**Re: Grand Rapids IRA Civic Center – West Venue Roof Capacity Review
NCE Job No. 17-665**

**Re: Grand Rapids IRA Civic Center – West Venue Roof – Truss Web Failure
NCE Job No. 17-665**

**Re: Grand Rapids IRA Civic Center – West Venue Roof – Truss Web Member Repair
NCE Job No. 17-665**

NCE		SK - 2
RTT	G.R. IRA Truss	Oct 20, 2017 at 11:02 AM
17-665	Current Snow Load = 46 PSF	17-665_Truss.r3d

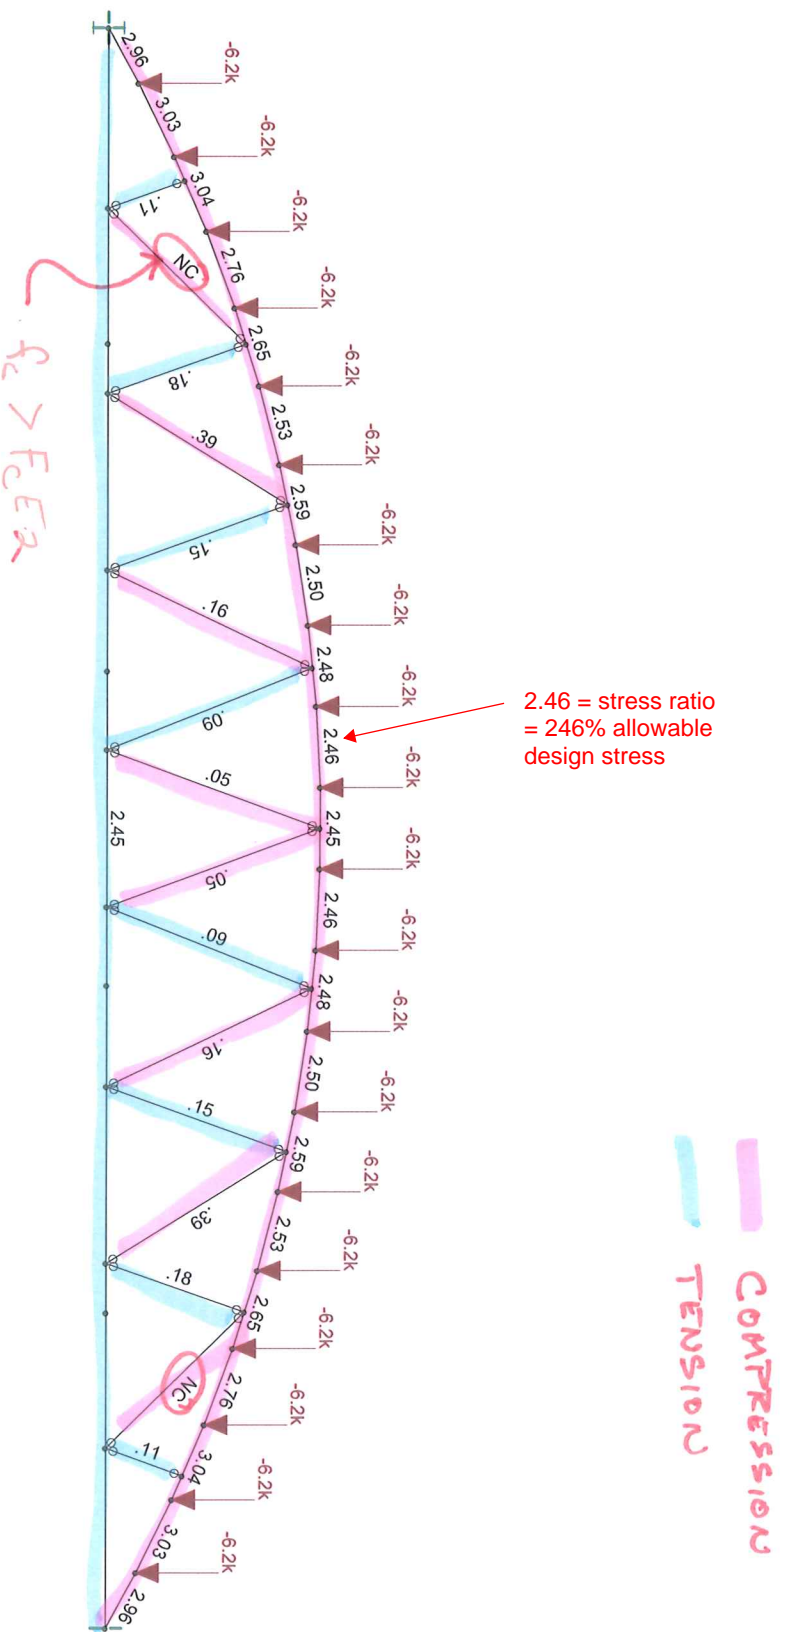
2. The 1962 Roof Trusses have a uniform snow load design capacity of approximately 20 psf.
3. The 1980's era roof trusses have a uniform snow load design capacity of approximately 30 psf.
4. Under unbalanced snow loading, several slender truss web members change from tension members to compression members, when this occurs, the truss can support only a design load of 15 psf over one half of the truss.
5. Connections: The connection capacity generally follows the member capacity, in other words the 1962 truss appears to have been professionally designed for 20 psf and the 1982 truss appears to have been professionally designed for 30 psf (both for uniform loading only)

1. In our professional opinion, the severe under-capacity of the 1962 roof trusses is a dangerous condition and should be corrected. We recommend reinforcing or replacing the existing roof structure as soon as possible.

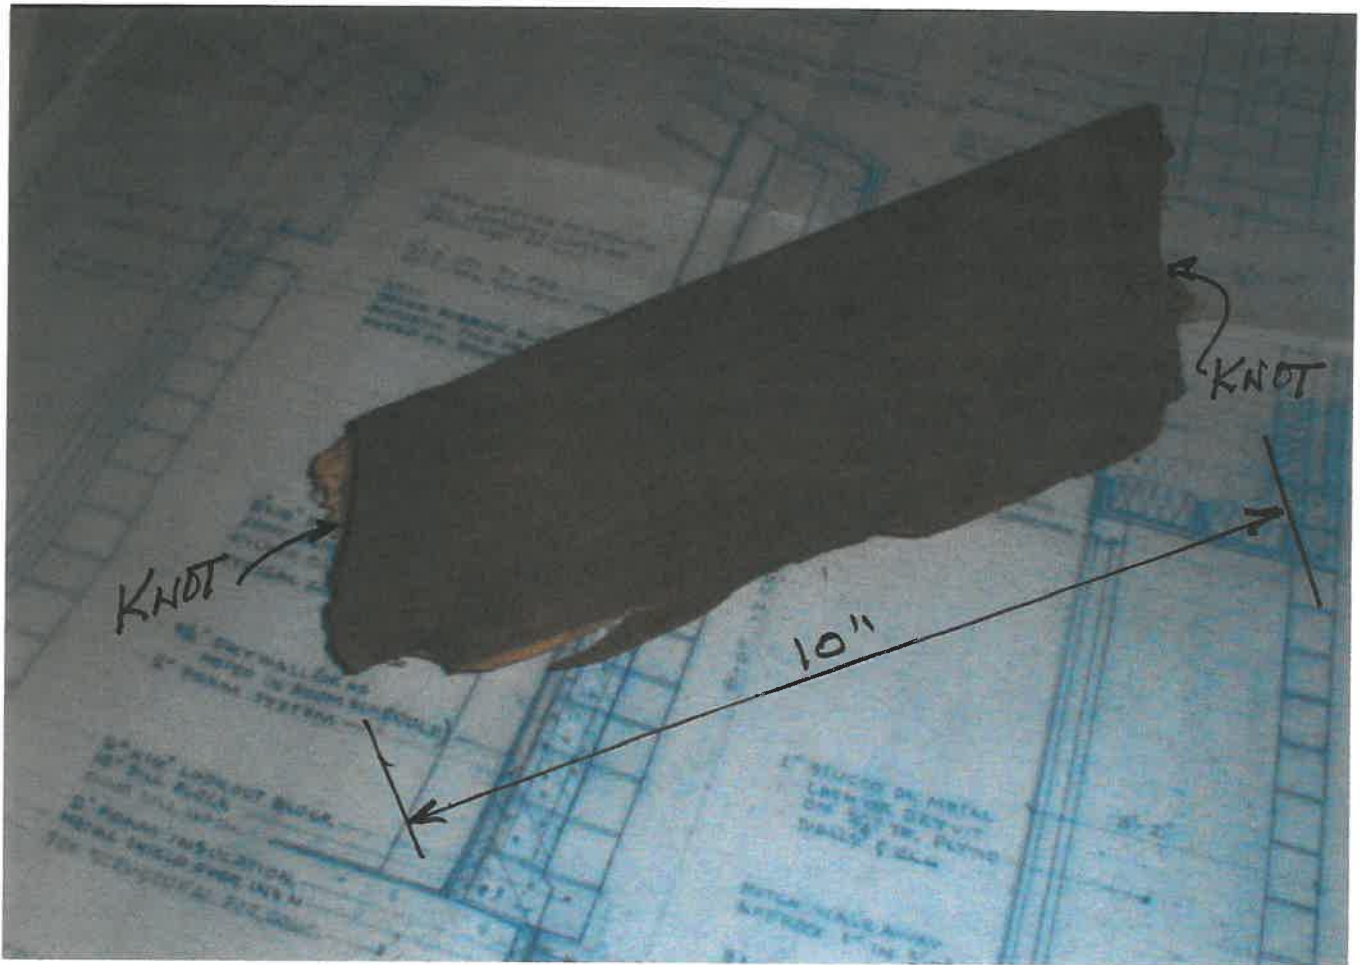
- 4.) The member that did fracture had a knots at two points of the fracture on a large piece found on the ice surface (see Appendix A, page A2). These knots further reduced the member's strength, hence the cause of the failure.

1
EXISTING TRUSS REPAIR
 1/4"=1'-0" (WEB MEMBER REPLACEMENT)

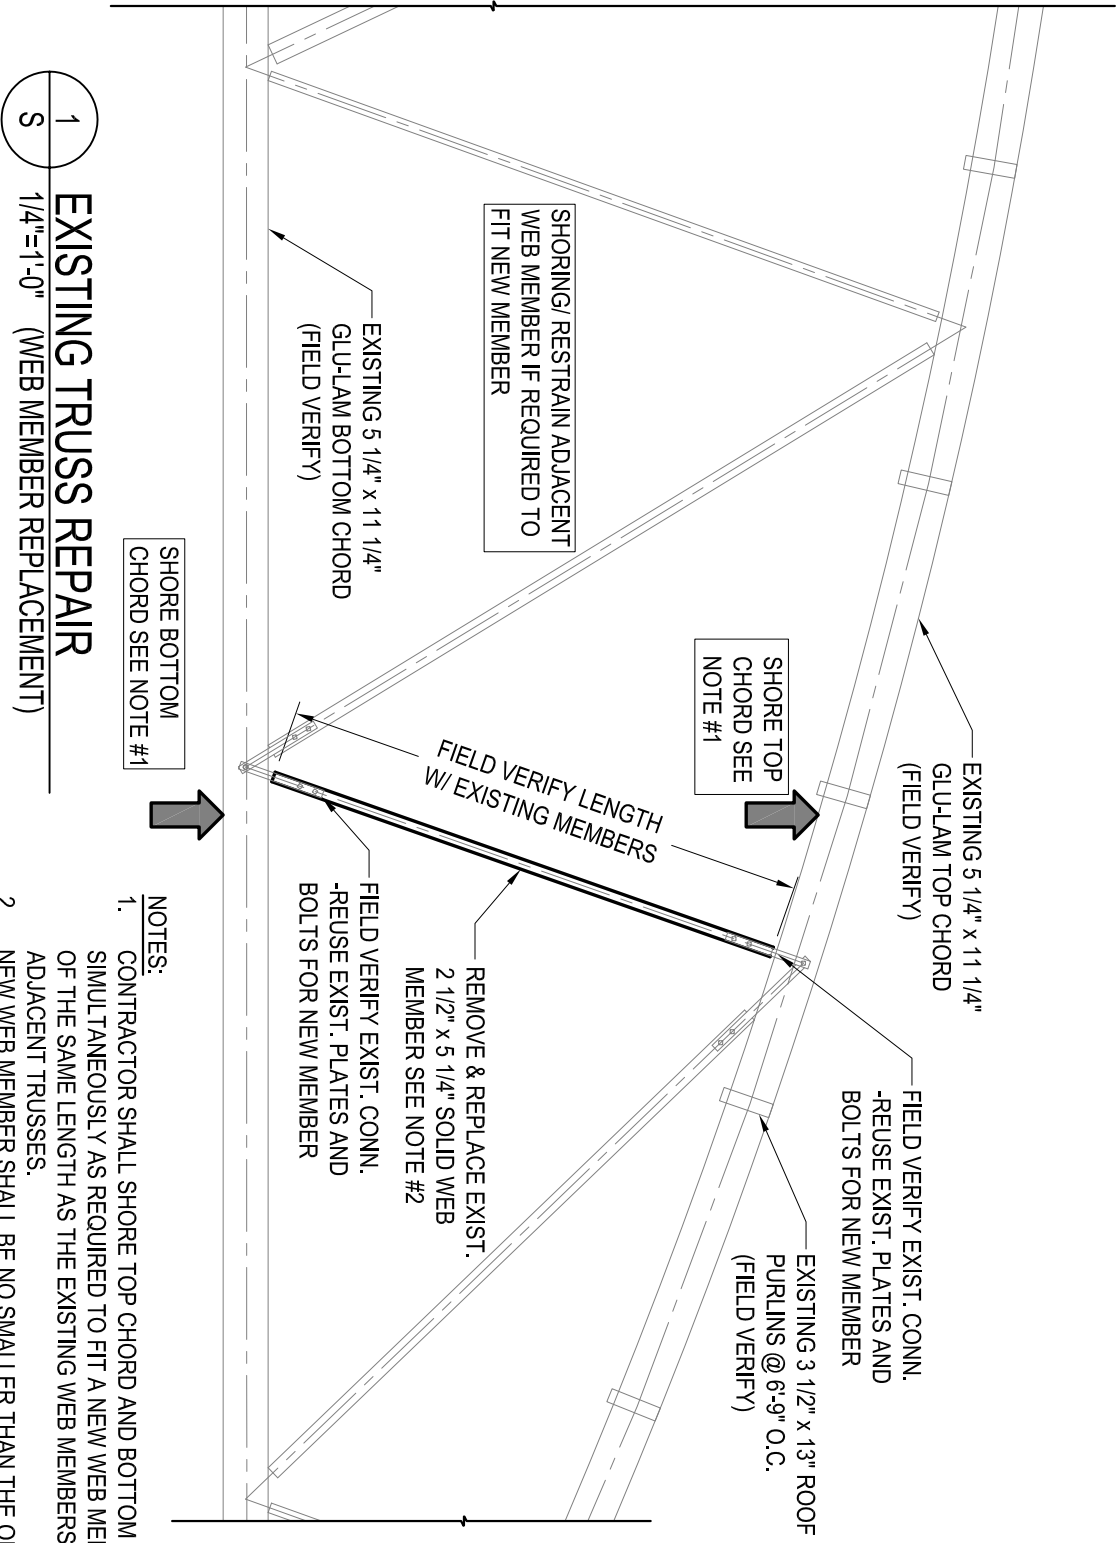
Attached to this letter, please find our repair detail for the failed member. In our opinion, it is possible that this failure is partially due to improper repair in the past, but it is also possible that the failure under light loading is partially or completely due to reduced capacity due to long term moisture changes. Therefore, as we discussed, in our professional opinion:

SHORE BOTTOM
 CHORD SEE NOTE #1

SHORE TOP
 CHORD SEE
 NOTE #1

- NOTES:**
- CONTRACTOR SHALL SHORE TOP CHORD AND BOTTOM CHORD SIMULTANEOUSLY AS REQUIRED TO FIT A NEW WEB MEMBER OF THE SAME LENGTH AS THE EXISTING WEB MEMBERS IN ADJACENT TRUSSES.
 - NEW WEB MEMBER SHALL BE NO SMALLER THAN THE ORIGINAL MEMBER AND SHALL BE D.F. #1 OR BETTER. ROSBORO X-BEAM GLU-LAM OF SIMILAR DIMENSIONS MAY BE USED.
